Agency of Transportation

Memorandum

SUBJECT: **Proposed parking in Jonesville**

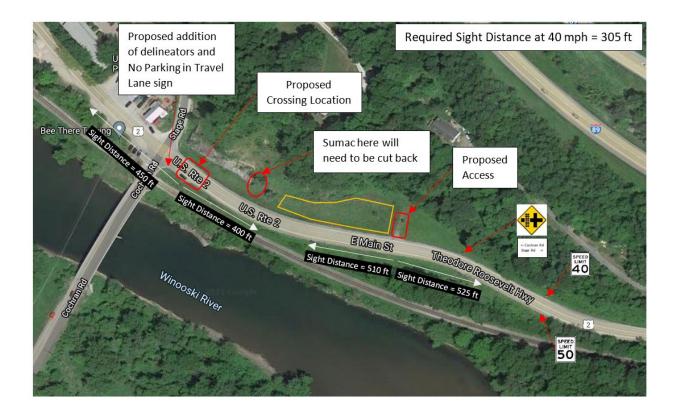
- 6. Sight distance was also measured to the approximate crossing location near the intersection with Cochran road and exceeded required distance in both directions. There is a small section of sumac and other vegetation at the north end of what is now mown that should be cut back to improve the line of sight.

- 7. From the north end of the mown area to Cochran Rd., the slope from the edge of Route 2 down to the toe of slope and the ledge is quite steep. If pedestrians will be directed to walk along this slope, it may be advisable to add some material to create a more level area. The town would have to investigate any environmental permitting concerns with filling in this area. Town will need to provide details of how this pedestrian route will be

designated (materials and location). The impact to drainage of any changes to this sloped area should be evaluated. It is possible that a small culvert would need to be installed.
